Index 521-611 Concrete Barrier/Junction Slab - Wall Coping (FRP)

COMMENTARY

There is an updated more comprehensive ASTM that has recently been made available.

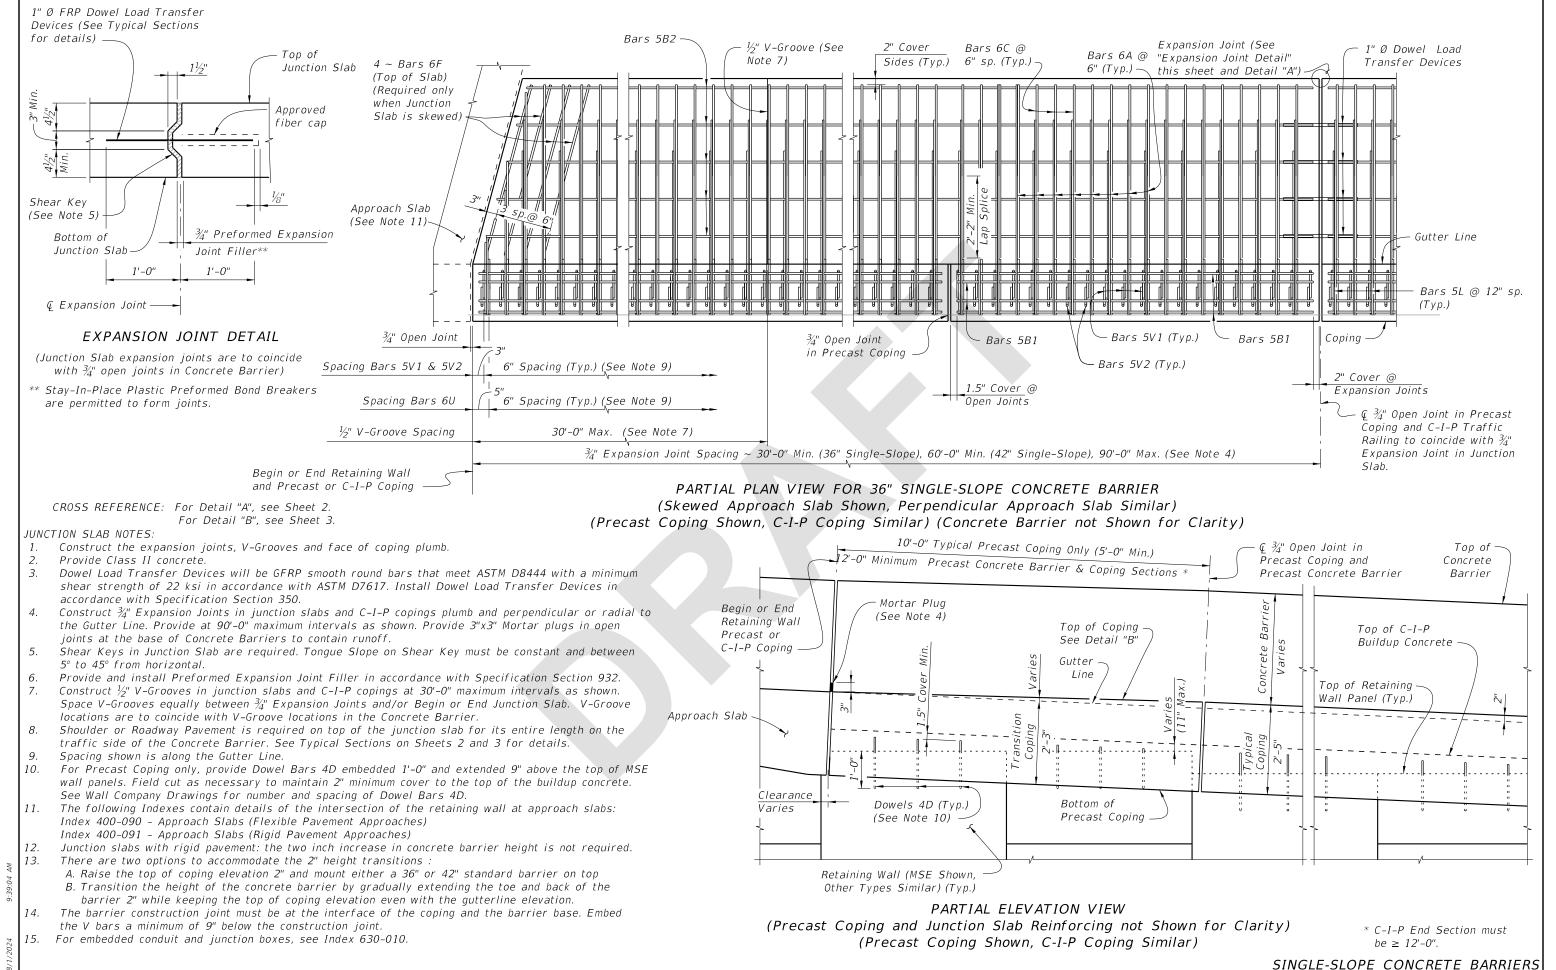
COMMENT: ASTM D8444 is a specification for Dowel Bars not a testing method. It probably refers to ASTM D7617 for shear strength testing. I understand the need to include ASTM D8444, since it is the more proper standard to refence for GFRP dowels. It can be included with the following language.

...GFRP smooth round bars that meet ASTM D8444 with a minimum shear strength of 22 ksi tested in accordance with ASTM D7617.

RESPONSE: Agreed. We will update.

CHANGE MADE TO INDEX: Updated language to match suggestion.
